Application No.: PL8335

| Record Type : | PLAT |

FINAL PLAT OF LOTS 43 AND 44, BLOCK D, LEXINGTON PLAZA

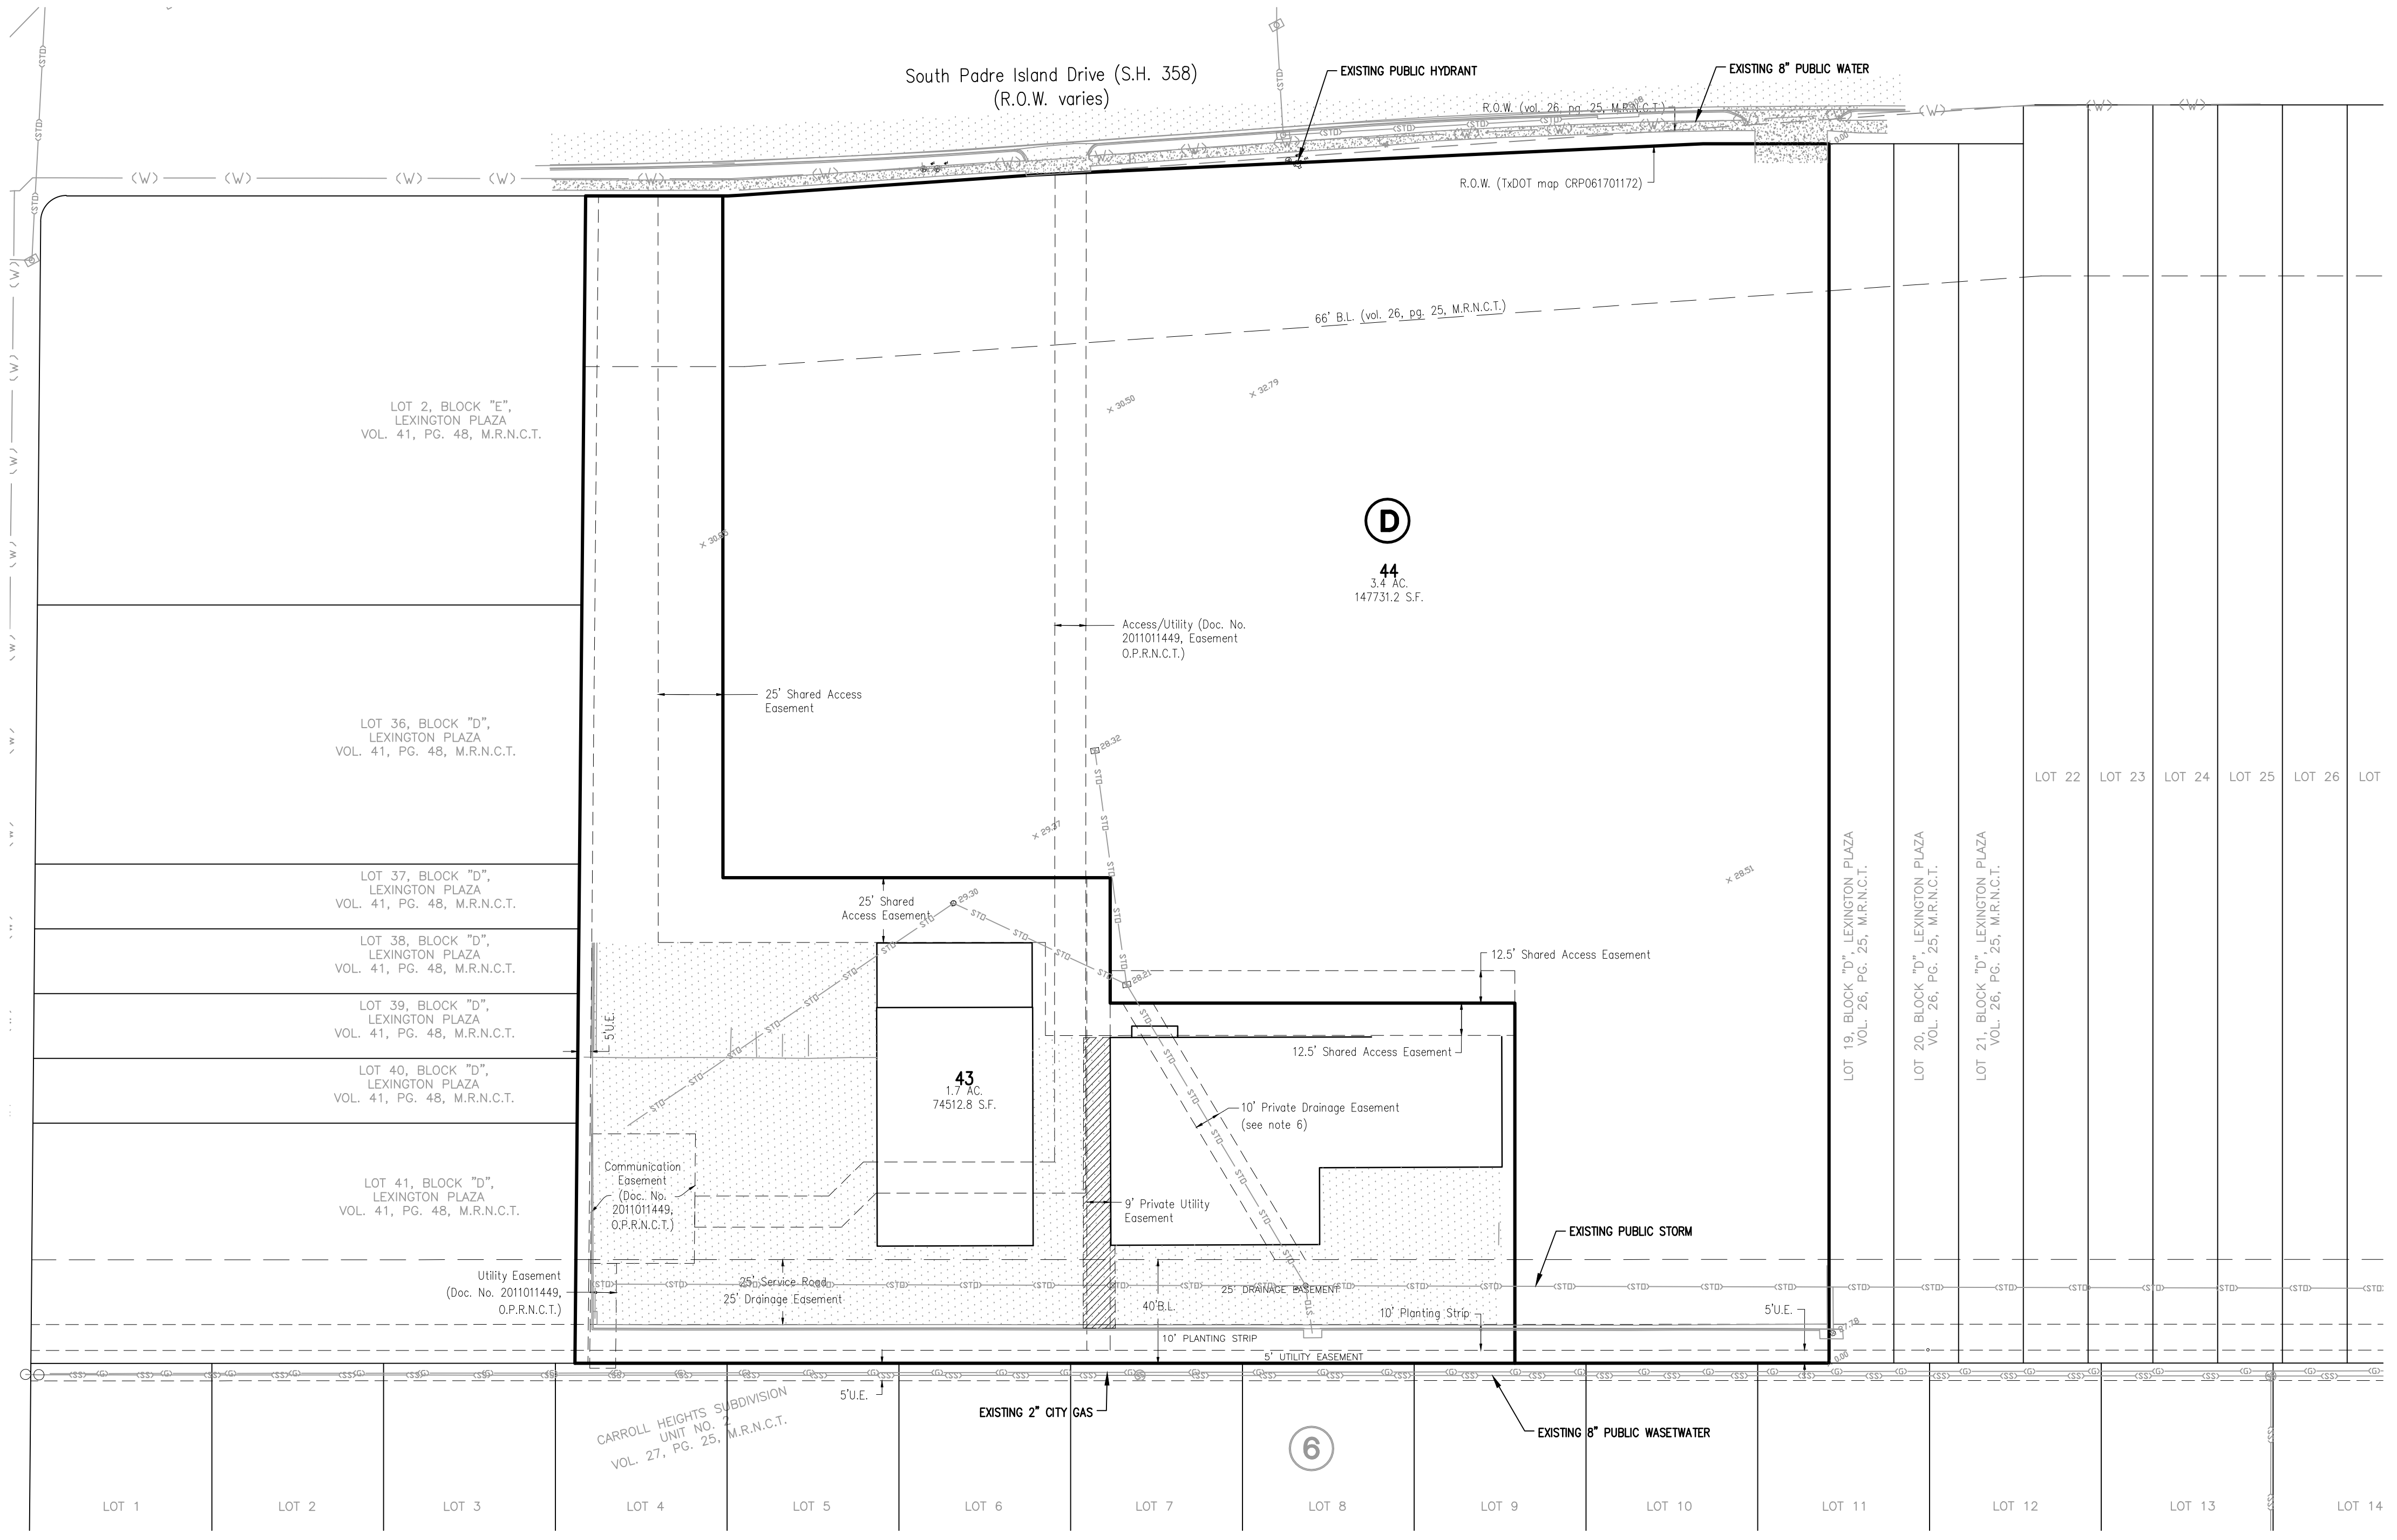
| Comment ID | Page Reference | Annotation Type | Author : Department | Status | Review Comments | Applicant Response Comments |
|------------|----------------------------------|-----------------|-----------------------|--------|---|-----------------------------|
| 16 | UTILITY PLAN | Note | Melanie Barrera : DS | Closed | no public improvements are needed for recordation | |
